SERVICE No. 205 BULLETIN

Piper Aircraft Corporation

Inspection of Circuit Protector Wiring

PA-24 and PA-24 "250" Comanches Serials 24-2512

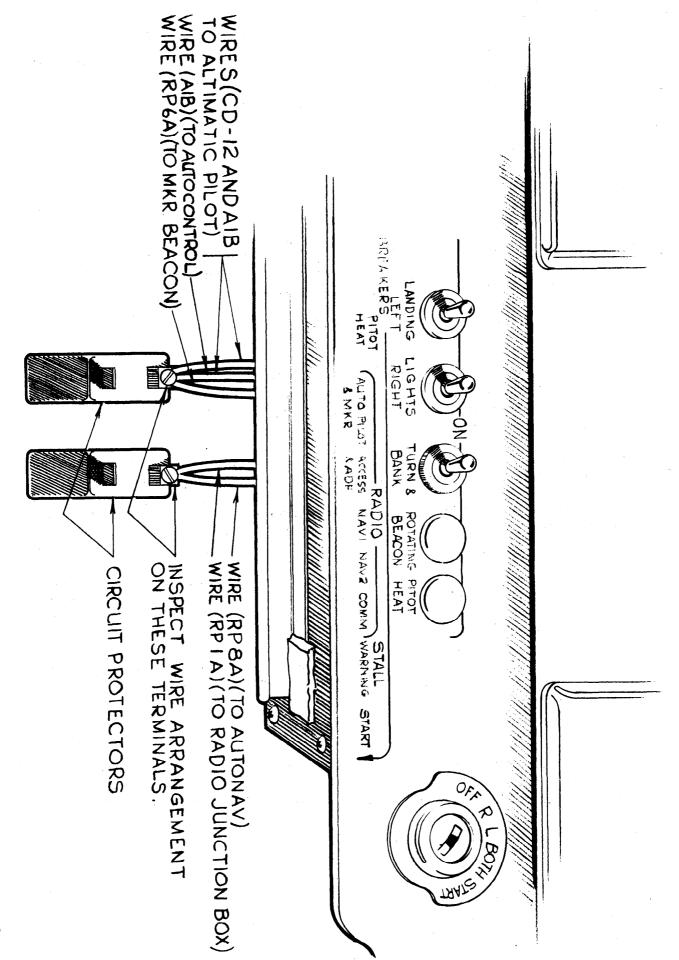
The two circuit protectors - (1) the Accessory and ADF circuit protector and (2) the AutoPilot and Marker Beacon circuit protector (to which the Piper Altimatic, Piper AutoControl or Narco Radio installation packages Numbers 1, 2 or 3 are installed) - may be wired in reverse.

It is requested that the wiring to these two circuit protectors be inspected, referring to the drawing on the reverse side of this Bulletin for the correct wiring.

- Open only the Accessory and ADF circuit protector. Be sure only the Accessory and ADF are inoperative. The Accessory may be checked by keying the hand microphone and noting whether or not there is a click in the speaker. There should be no clicking with the Accessory and ADF circuit protector opened. Reset the circuit protector.
- 2. Open only the AutoPilot and Marker Beacon circuit protector. Be certain only the AutoPilot and Marker Beacon are inoperative. The Accessory and ADF should be operative.

If the inspection of the wiring and the test as outlined above are satisfactory, no further action will be required. However, if the circuits are wired in reverse, then they must be rewired as indicated by the referenced sketch.
